Detailed Site Plan Marlboro Gateway

DSP-22019

STAFF REPORT

SUBJECT: Detailed Site Plan DSP-22019
 Type 2 Tree Conservation Plan TCP2-046-2022
 Marlboro Gateway

Figure 1: Site Plan

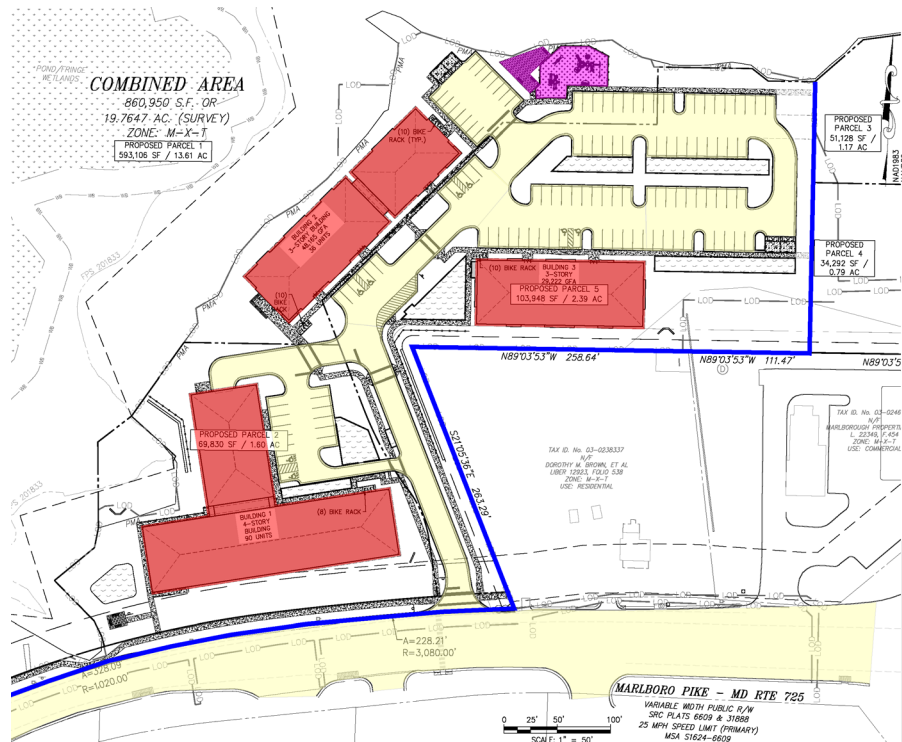
The site plan shows three retaining walls located near Buildings 1 and 2 to accommodate the steep topography of the site. These walls vary from 2 to 19.6 feet in height and are proposed to be constructed of modular concrete blocks. However, the detail for these retaining walls does not specify the color of the concrete blocks. A condition has been included herein, requiring that the color of the retaining wall blocks match the color of the masonry brick used in the buildings.

The DSP also includes details for trash receptacles. The site plan, however, does not indicate the location(s) where these trash receptacles will be provided. At a minimum, trash receptacles should be provided near the picnic tables and the play area, and along the pedestrian paths close to building entrances.

LANDSCAPE PLAN

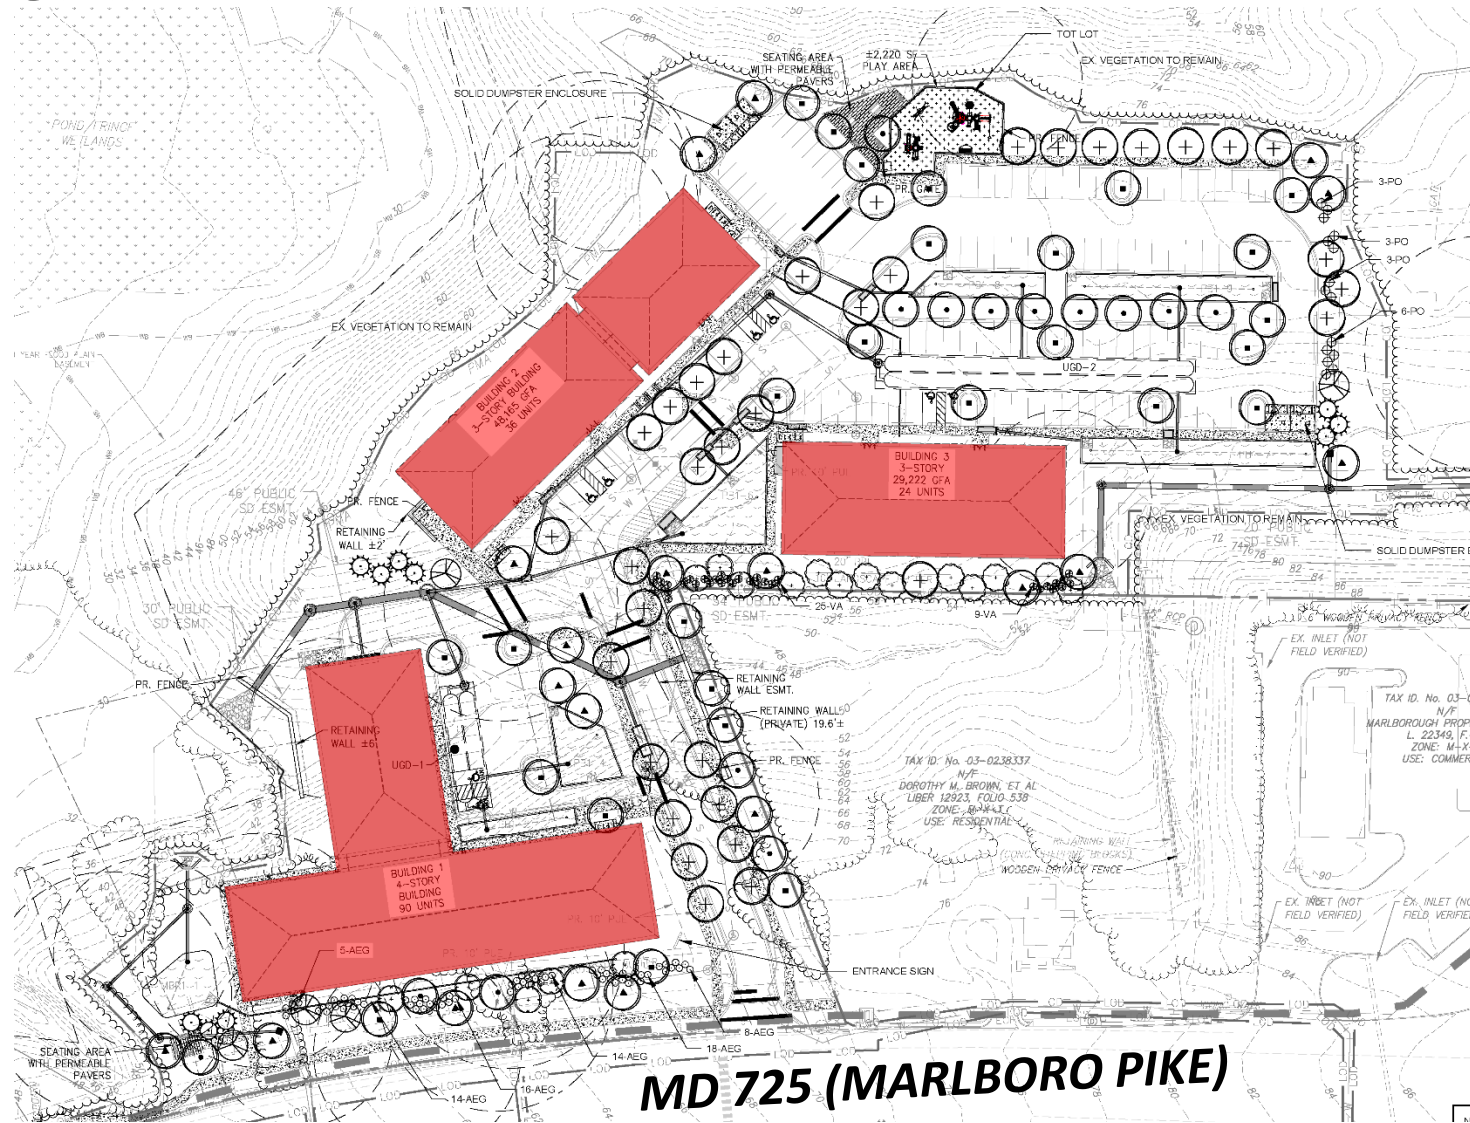
The detailed plan of the tot lot depicts engineered wood fiber as the surfacing of the play area. However, the cost estimate provided on the coversheet lists rubber surfacing. Staff finds that rubber surfacing is safer, more durable, and more desirable than engineered wood fiber surfacing. Therefore, the details shall be revised to specify rubber surfacing for the play area, prior to signature approval of the DSP.

The DSP proposes two seating areas for passive recreation. A small seating area, approximately 220 square feet in area, is proposed between Building 1 and MD 725. This seating area is accessible via a pedestrian path from both Building 1 and the public sidewalk fronting MD 725. Dense planting of evergreen and shade trees is proposed to shelter this seating area from the public street. However, this area is subject to nuisance noise levels due to proximity to MD 725 and should be removed. A second, larger seating area of approximately 930 square feet is proposed near the play area. This seating area provides seating benches and picnic tables. The surface of this seating area is proposed to be permeable pavement for which a detail has been provided in the DSP. The permeable pavement appears to be constructed of open pavers, which could be of concern for not being ADA-compliant. A note shall be added to the detail of permeable pavement, stating that the surface will be ADA-compliant. The site plan should also be revised to provide a detail for the proposed picnic tables.
